CHART HOUSE HOTEL
 850 BAYWAY BOULEVARD
 CLEARWATER, FLORIDA

BUILDING FLOOR PLAN - FIRST FLOOR

PROPOSED 60 UNIT HOTEL
850 Bay Way Blvd,
City of Clearwater, Florida 33767

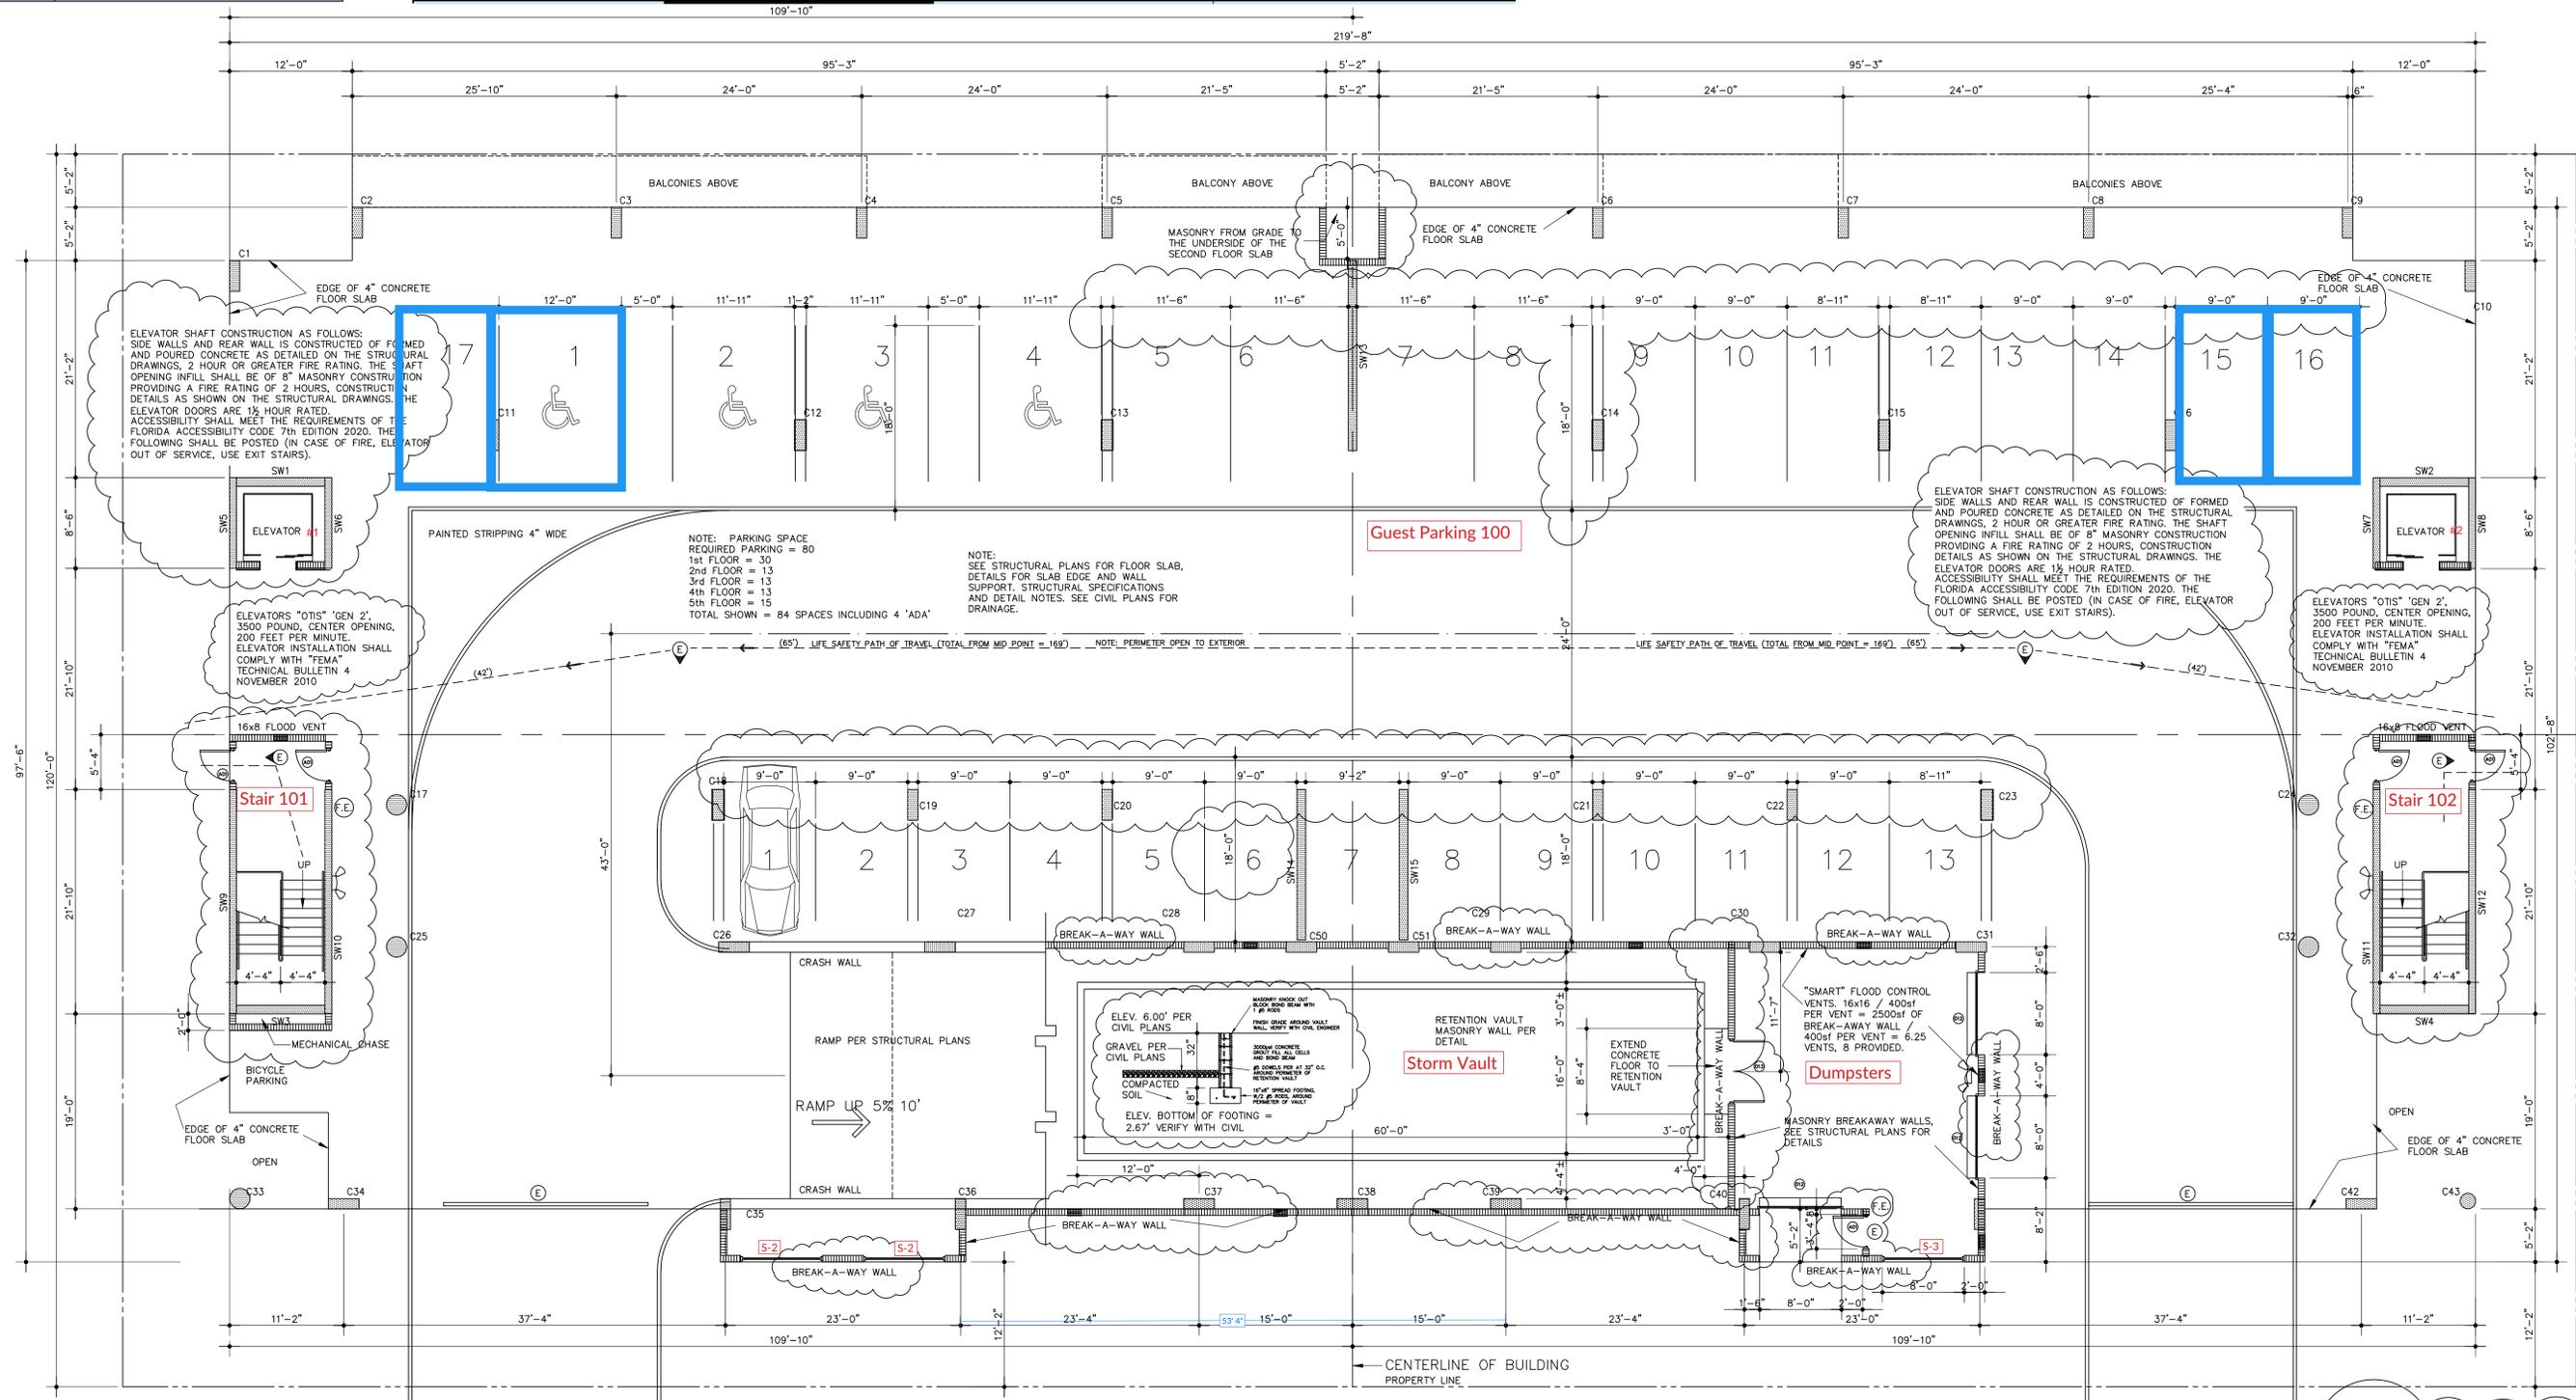
5/26/2023 FLOOD CONTROL VENTS ADDED TO BREAK-A-WAY WALL IN THE UNDER RAMP AREA AND BOTH STAIRWELL END WALL. 16x8 VENTS (200sf) AND (16x16) VENTS (400sf)

BUILDING FLOOR PLAN - SECOND FLOOR
LIFE SAFETY PATH OF TRAVEL SHOWN

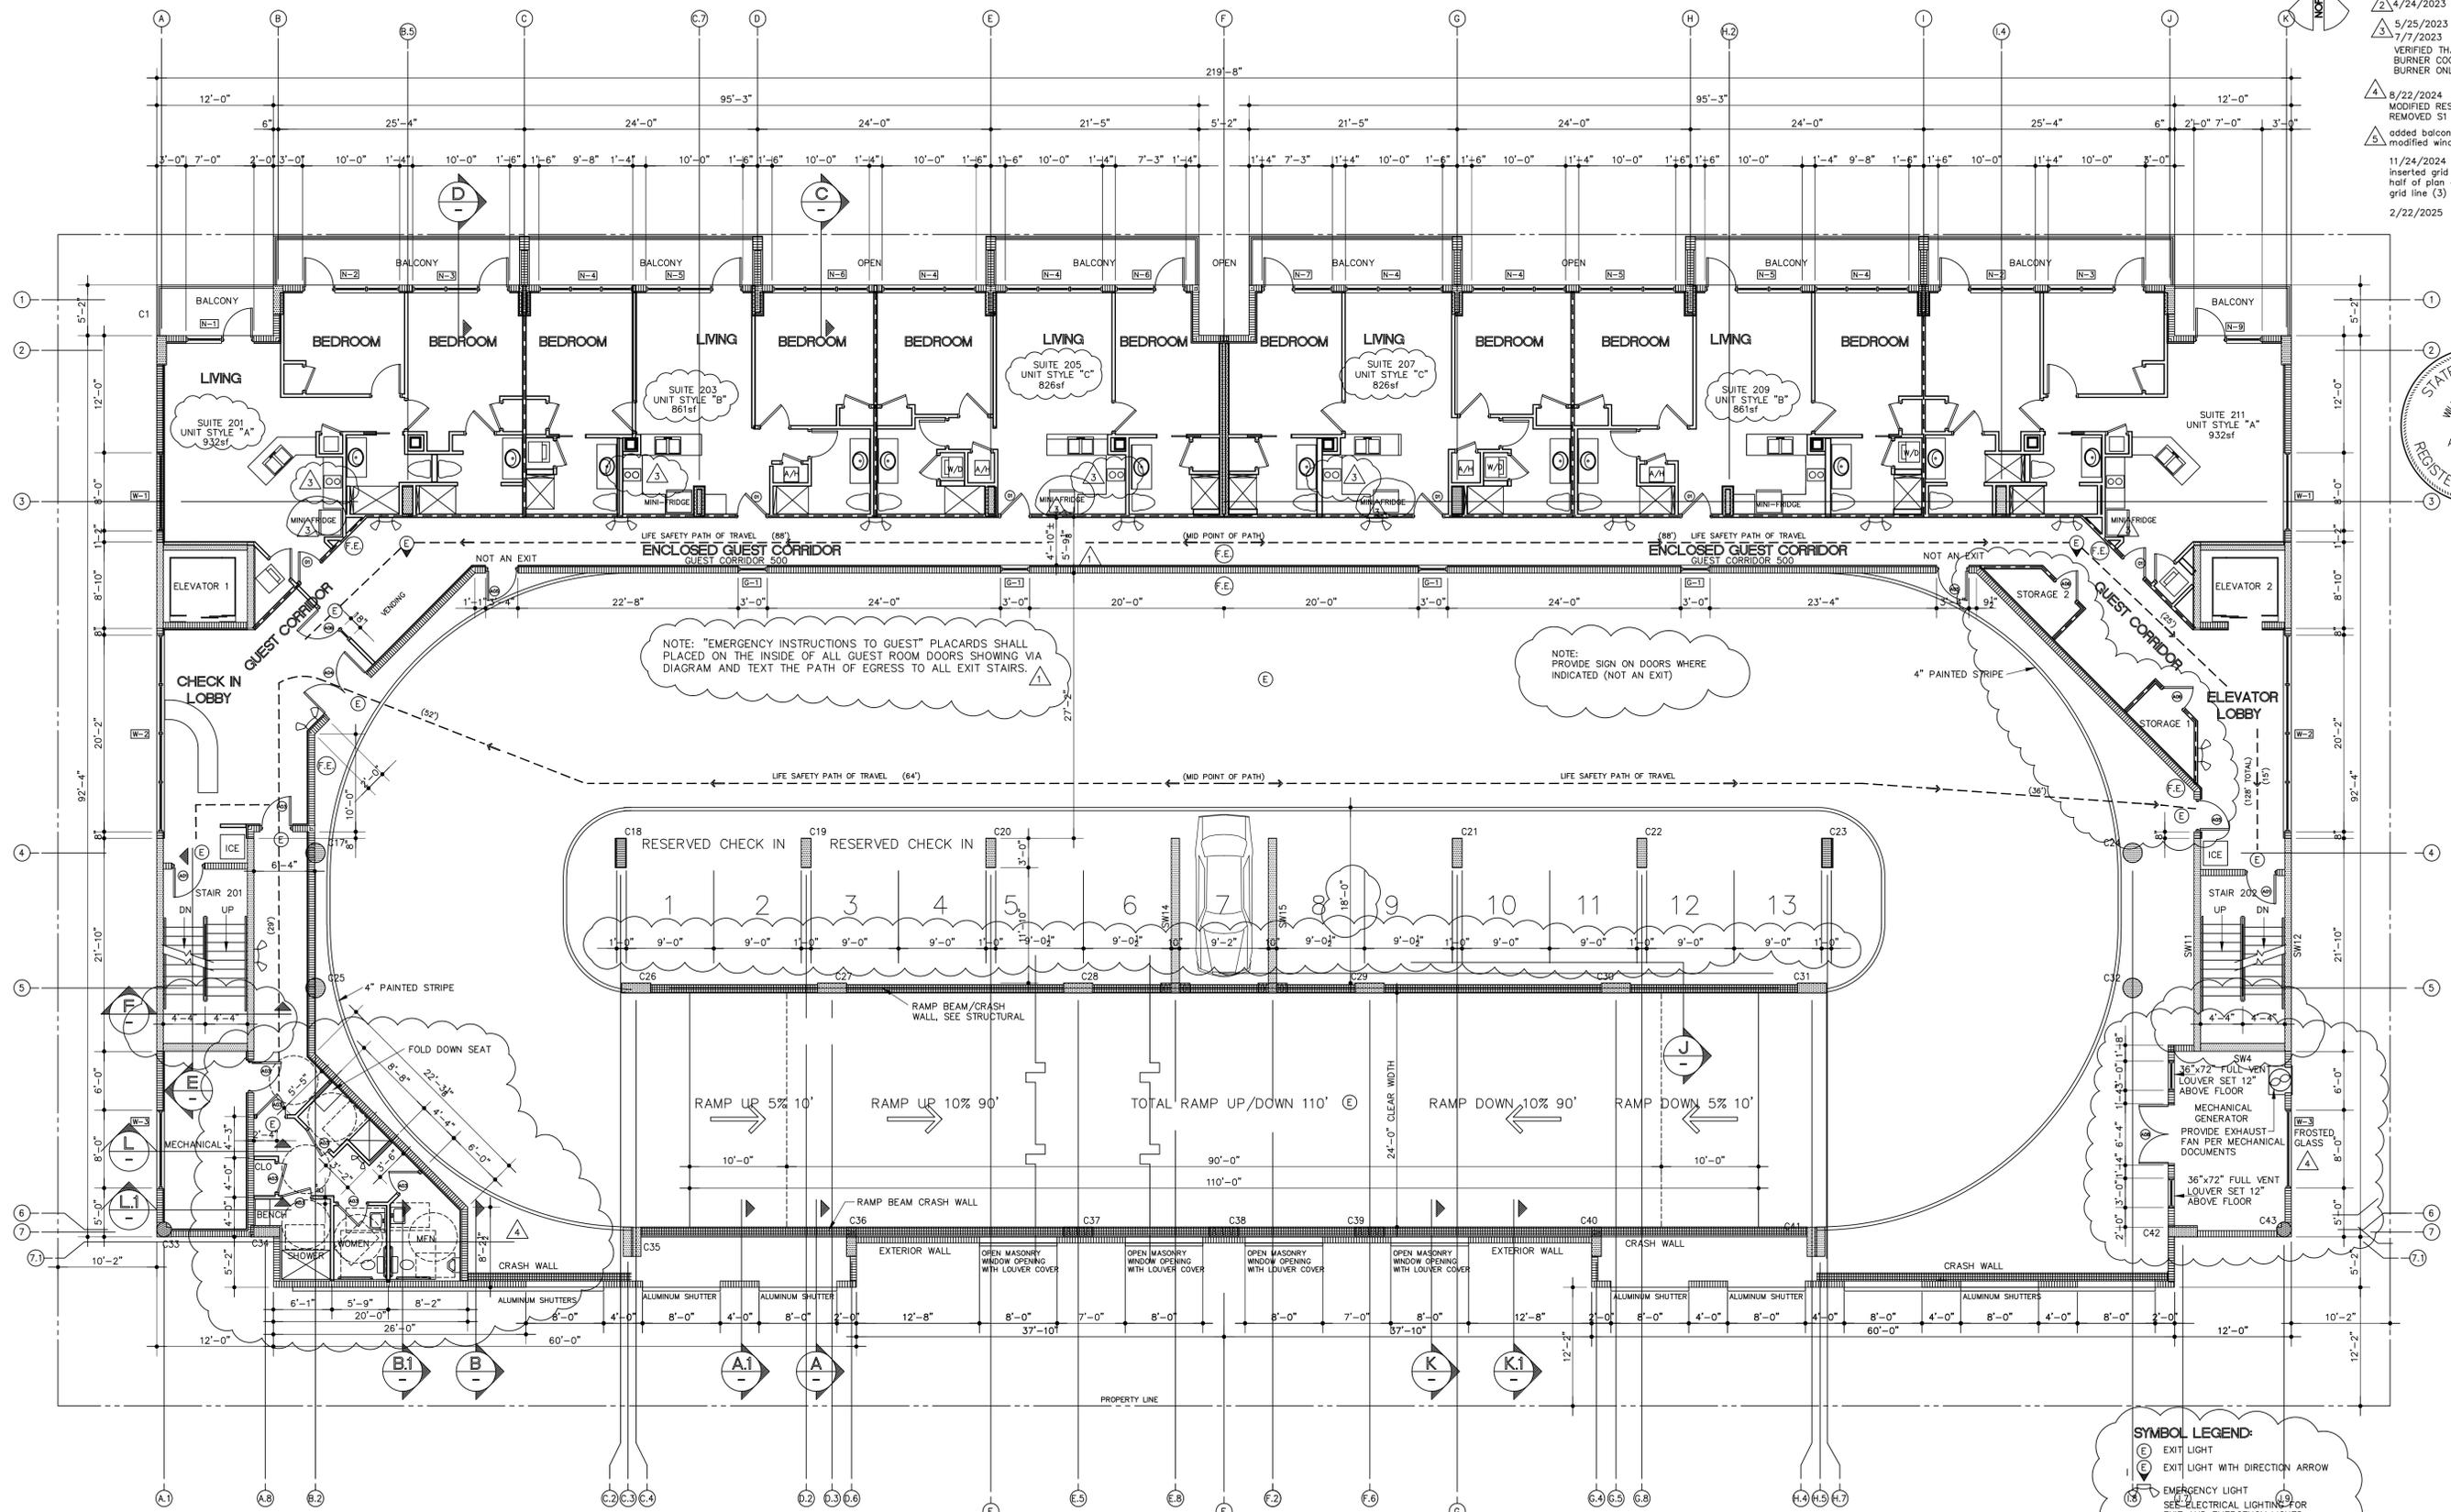
VERIFIED THAT NO FOUR BURNER COOK TOPS, TWO BURNER ONLY

MODIFIED RESTROOMS / REMOVED 51 WINDOWS
added balcony on unit type "A" modified window to include door

Inserted grid revise east half of plan at columns along grid line (3)
